# Generic Environmental Impact Statement for License Renewal of Nuclear Plants

Main Report  
Section 6.3—Transportation  
Table 9.1 Summary of findings on NEPA  
issues for license renewal of nuclear power  
plants

Final Report

U.S. Nuclear Regulatory Commission  
Office of Nuclear Reactor Regulation  
Washington, DC 20555-0001

**Figure A.2. Routes analyzed in this study.** 1 = from the northeast through downtown (I-15 to 95), 2 = from south through downtown (I-15 to 95), 3 = from the northeast using the Beltway (I-15 to I-215 to 95), 4 = from the south using the Beltway (I-15 to I-215 to 95).

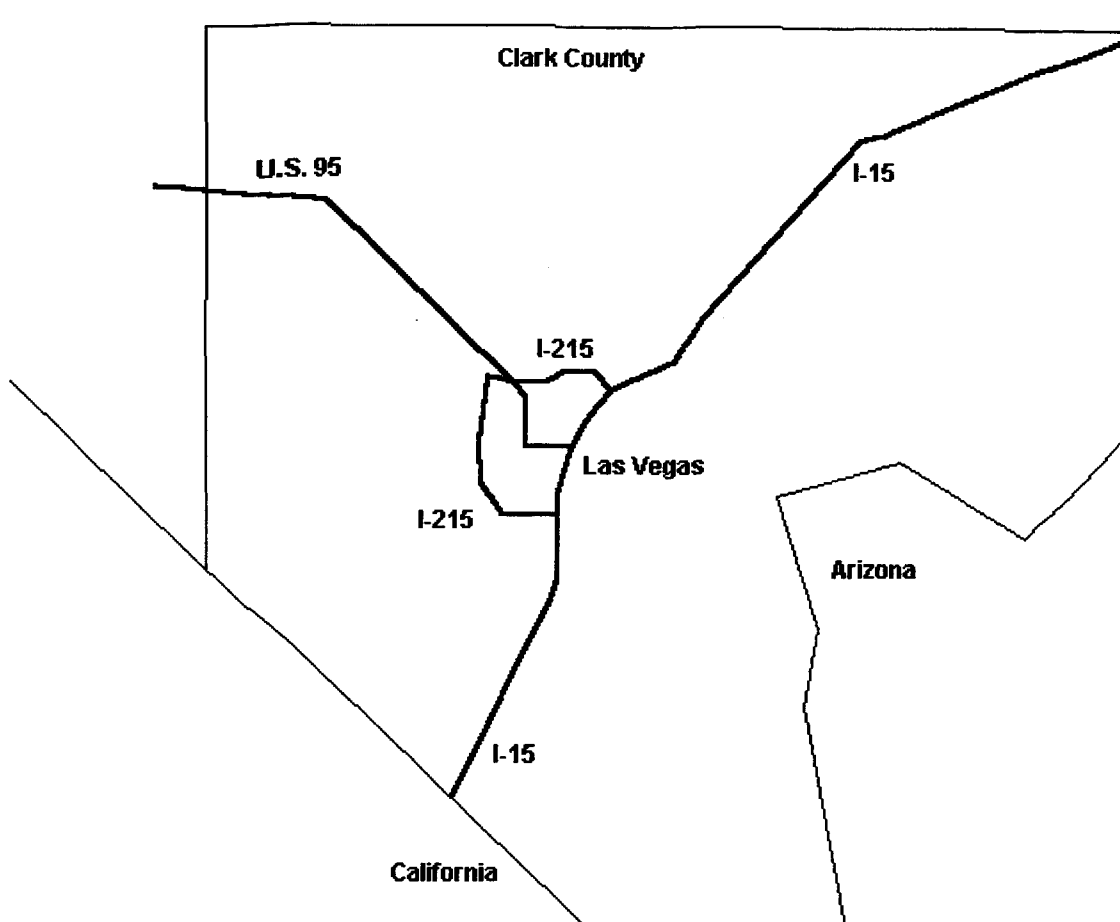
Comment: Addendum 1 assumes that truck transport would have the highest doses. This assumption is not necessarily valid. Also, a different route that avoids Las Vegas should be addressed. (A route through Nellis Air Force Base and down US-95 is being considered by DOE and it has been shown to have higher risks of accident fatalities and to increase the radiological risk.) Routes chosen in Addendum 1 do not bound the analysis properly.

Comment: The study area is inaccurately defined and the location of some cities is incorrectly stated.

Response: The transportation and route scenarios and their underlying assumptions were designed to reflect situations that most likely would result in highest doses in order to bound the analysis properly as the routes chosen for this analysis were the most populated routes in the state of Nevada. Also, as noted in an earlier response, the NRC staff consulted DOE in determining that truck shipments through densely populated areas of Clark County, Nevada, would have the highest potential impacts among the alternative transportation scenarios that would be given serious consideration in decisions relating to the suitability of the site undergoing study for a repository at Yucca Mountain.

The comment that a route from Nellis Air Force Base down US-95 is higher risk than those selected by the NRC staff provided no specific details concerning that assertion. In the NRC staff's view, any route that bypasses major centers of population will have significantly lower radiological impacts. With regard to traffic accident rates, while it may be true that certain routes will have accident rates that are higher than average, the average rates are low enough that modest increases from the average will not significantly change the staff's conclusions.

Response: During the preparation of Addendum 1, the initial study area selected for analysis emphasized the urban areas in and near Las Vegas. Route selections were based in part on their proximity to those areas, not to county borders. However, in response to public comments, the study area was expanded to include the entire county. Consequently, the "entry" point for SNF shipments shifted to cities such as Mesquite.
